Source: T1
Title: CR's to TS 34.121 v3.4.0 for approval
Agenda item: 5.1.3
Document for: Approval

This document contains 15 CRs to TS 34.121 v3.4.0. These CRs have been agreed by T1 and are put forward to TSG T for approval.

⌘ **34.121 CR 083** ⌘ rev **-** ⌘ Current version: **3.4.0** ⌘

Title:	⌘ Addition of Test System uncertainties and Test Tolerances		
Source:	⌘ T1/RF		
Work item code:	⌘	Date:	⌘ 16/05/01
Category:	⌘ F	Release:	⌘ R99
<p>Use <u>one</u> of the following categories:</p> <p>F (essential correction) A (corresponds to a correction in an earlier release) B (Addition of feature), C (Functional modification of feature) D (Editorial modification)</p> <p>Detailed explanations of the above categories can be found in 3GPP TR 21.900.</p>		<p>Use <u>one</u> of the following releases:</p> <p>2 (GSM Phase 2) R96 (Release 1996) R97 (Release 1997) R98 (Release 1998) R99 (Release 1999) REL-4 (Release 4) REL-5 (Release 5)</p>

Figure 5.4.2.4 Inner Loop Power Control Test Steps

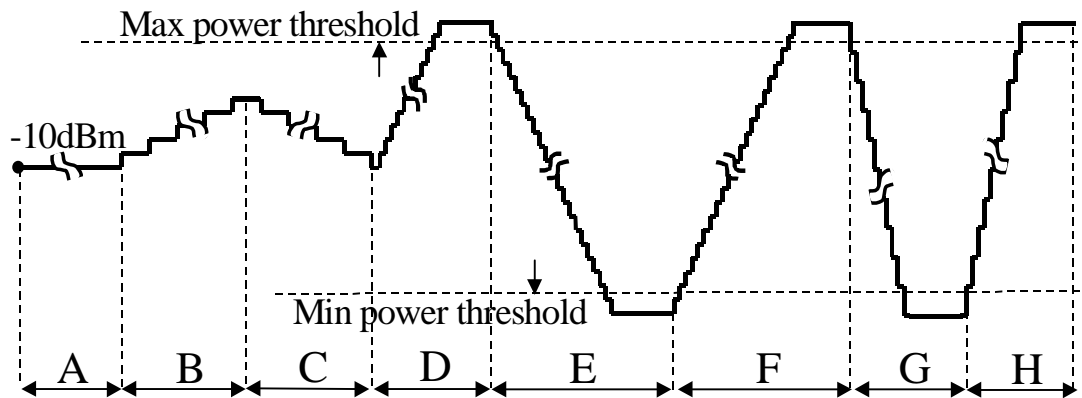
- 1) Before proceeding with paragraph (2) (Step A) below, set the output power of the UE, measured at the UE antenna connector, to be in the range -10 ± 9 dBm. This may be achieved by setting the downlink signal (\hat{I}_{or}) to yield an appropriate open loop output power and/or by generating suitable downlink TPC commands from the SS.
- 2) Step A: Transmit a sequence of at least 30 and no more than 60 TPC commands, which shall commence at a frame boundary and last for a whole number of frames, and which shall contain:
 - no sets of 5 consecutive "0" or "1" commands which commence in the 1st, 6th or 11th slots of a frame;
 - at least one set of 5 consecutive "0" commands which does not commence in the 1st, 6th or 11th slots of a frame;
 - at least one set of 5 consecutive "1" commands which does not commence in the 1st, 6th or 11th slots of a frame.

¹ NOTE: These numbers of TPC commands are given as examples. The actual number of TPC commands transmitted in these steps shall be at least 10 more than the number required to ensure that the UE reaches the relevant maximum or minimum power threshold in each step, as shown in Figure 5.4.2.4.

Figure 5.4.2.4 Inner Loop Power Control Test Steps

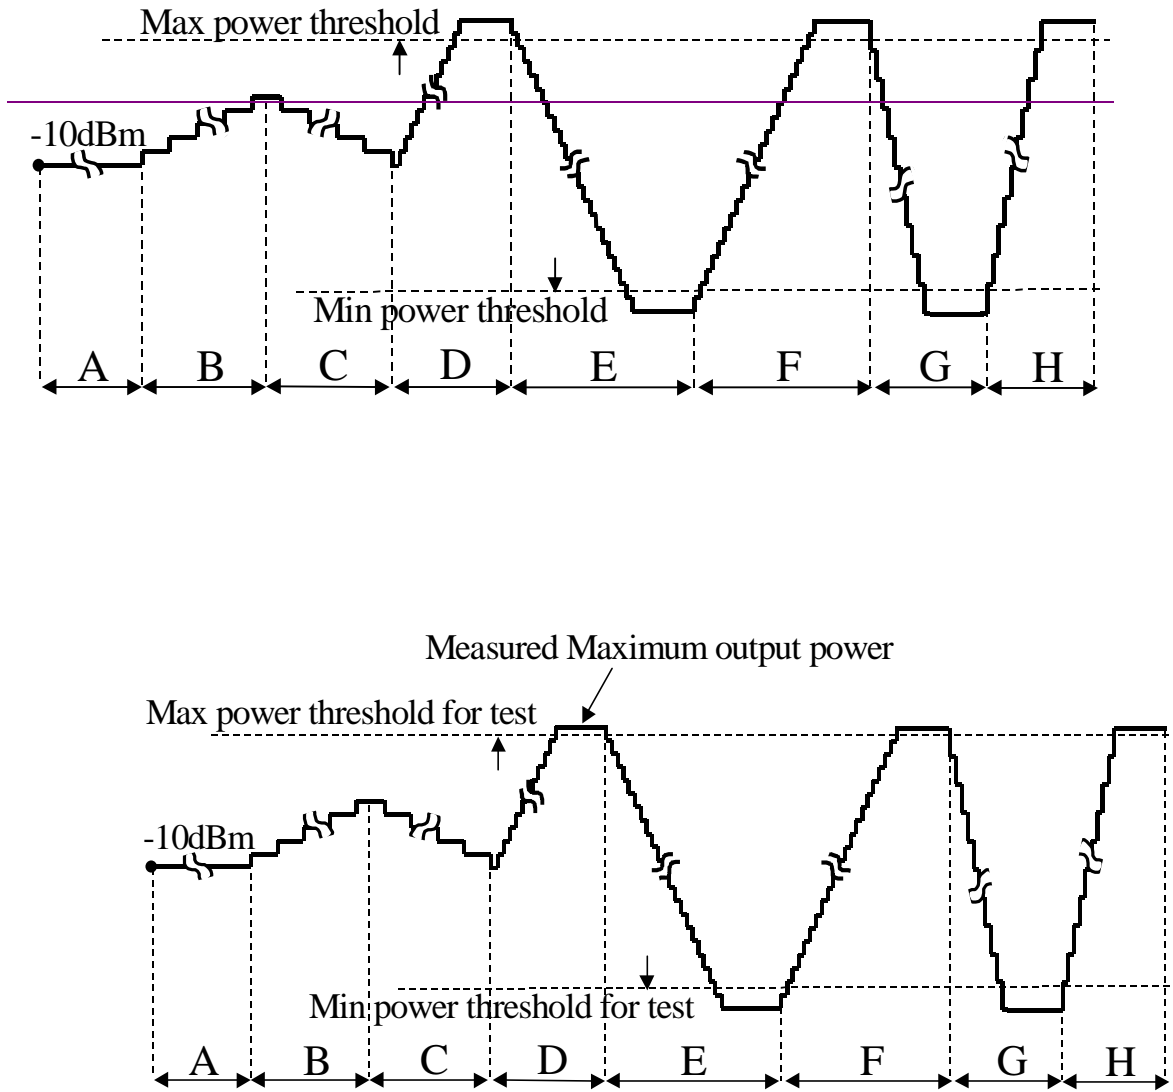
- 1) Before proceeding with paragraph (2) (Step A) below, set the output power of the UE, measured at the UE antenna connector, to be in the range -10 ± 9 dBm. This may be achieved by setting the downlink signal (\hat{I}_{or}) to yield an appropriate open loop output power and/or by generating suitable downlink TPC commands from the SS.

¹ NOTE: These numbers of TPC commands are given as examples. The actual number of TPC commands transmitted in these steps shall be at least 10 more than the number required to ensure that the UE reaches the relevant maximum or minimum power threshold in each step, as shown in Figure 5.4.2.4.
